PLANS AND DOCUMENTS
referred to in the PDA
DEVELOPMENT APPROVAL

Approval no: DEV207/892

PROJECT
SRACC
HERSTON ROAD,
HERSTON, QLD.

DRAWING TITLE
GENERAL ARRANGEMENTS PLAN

DRAWING TITLE
SECTIONS
SHEET 5

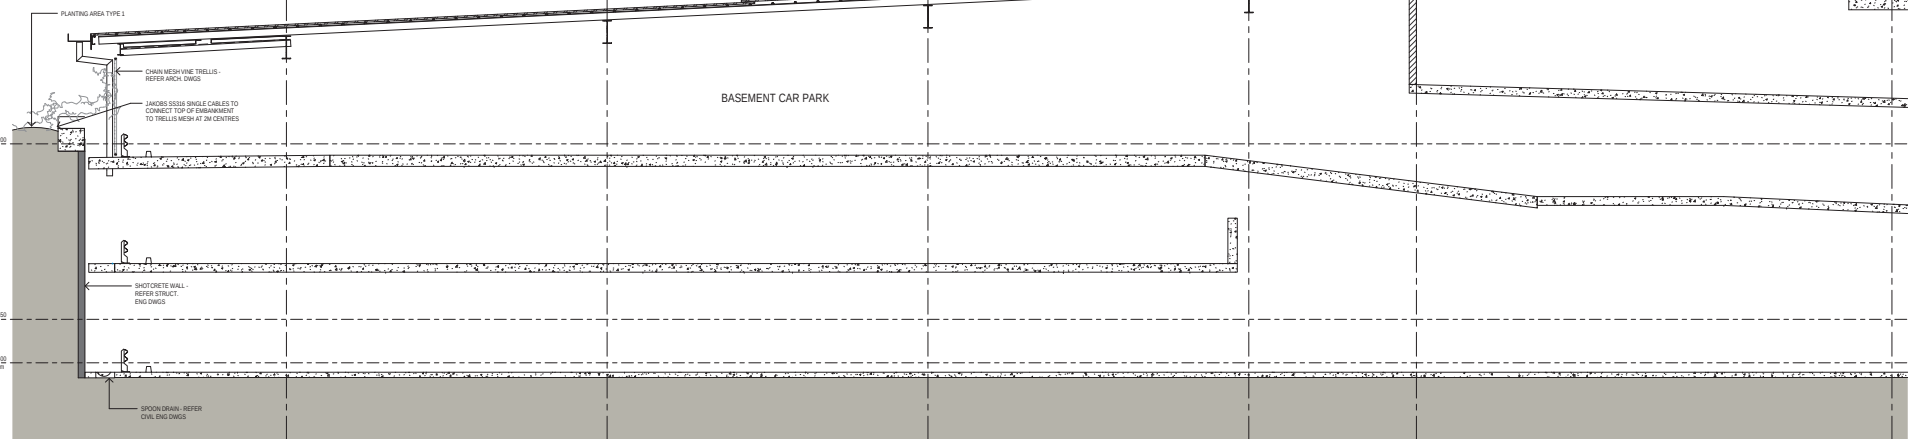
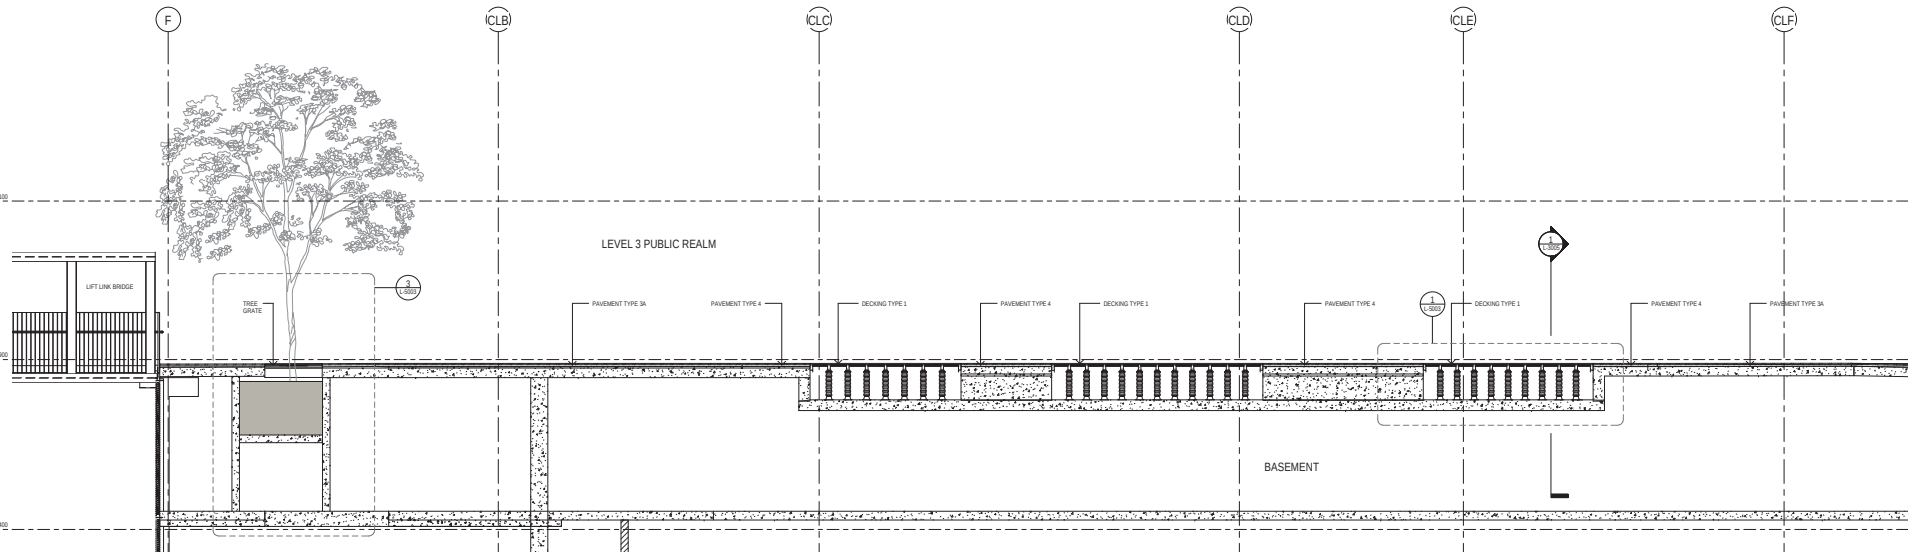
AMENDED IN RED

Screening to be
addressed under
condition 33 of this
approval.

SRACC LEVEL 037 PLAN

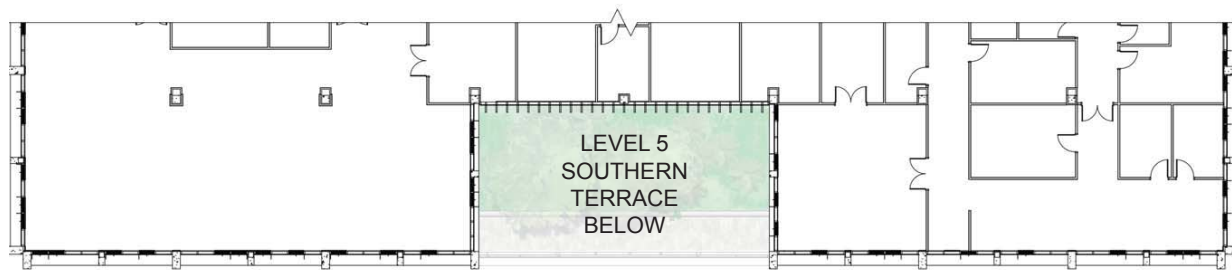
AMENDED IN RED

Public Realm Staging Plan

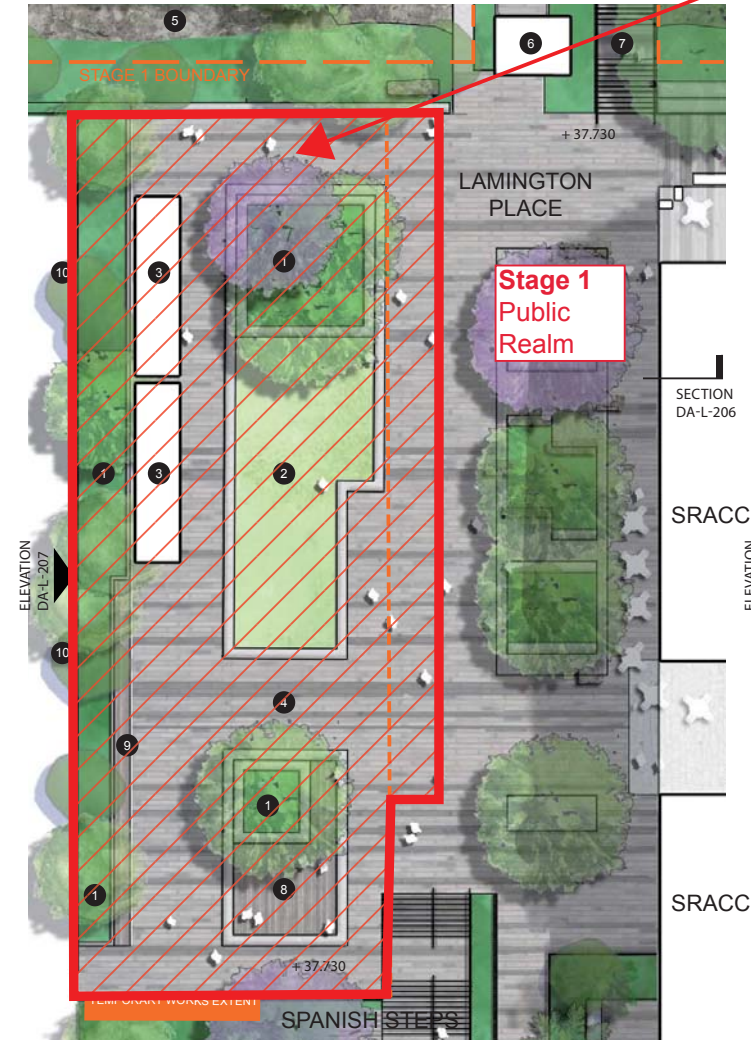
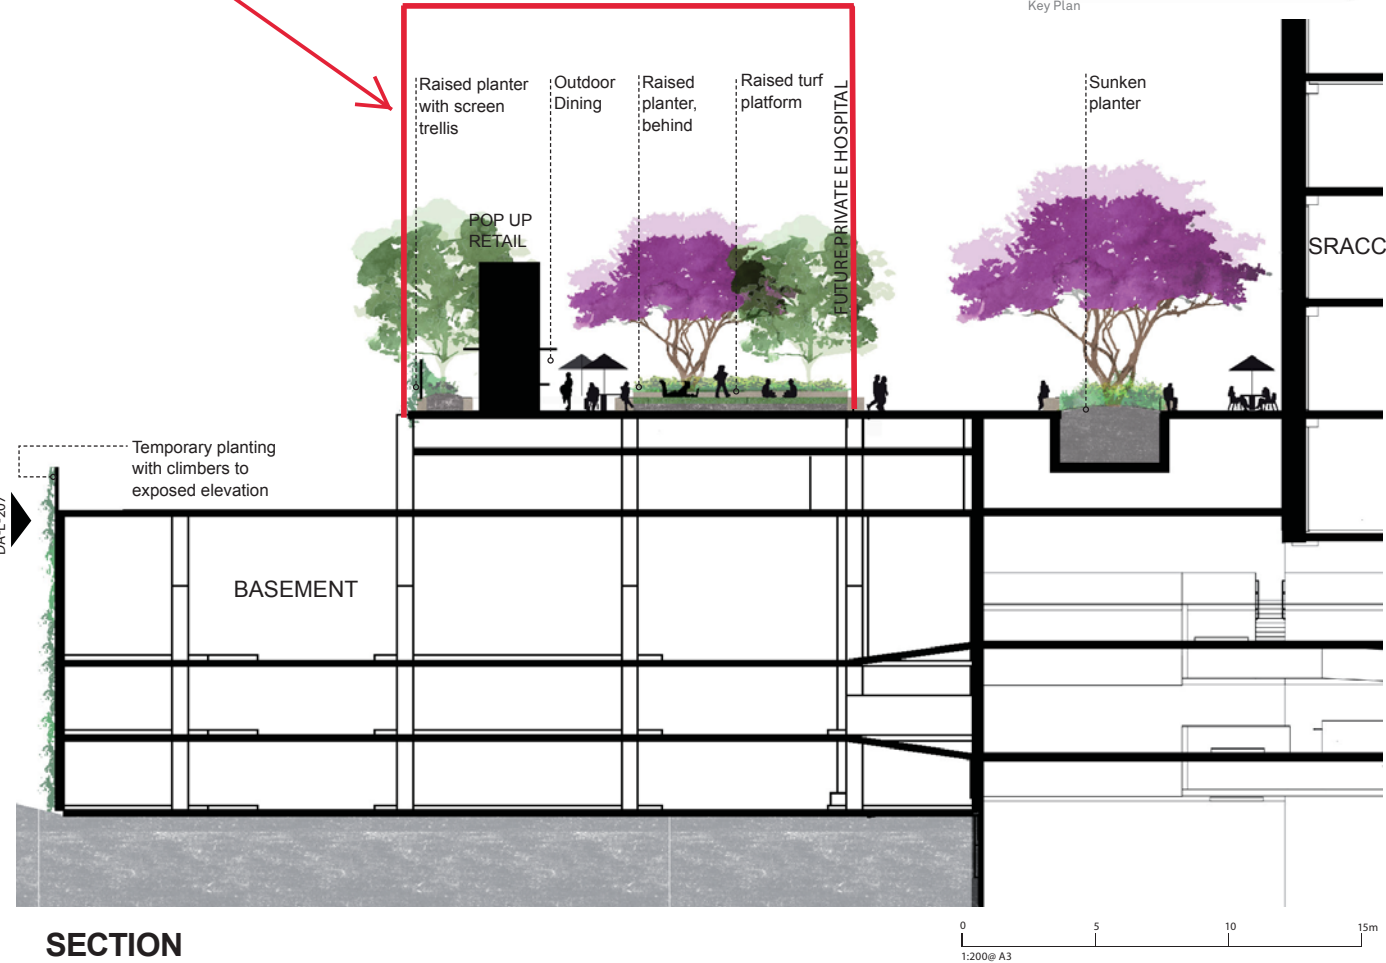
AMENDED IN RED

Stage 2 Public Realm - Extent of work to be
delivered in accordance with Condition 33 (c)

~~TEMPORARY
ACTIVATION PLAN~~
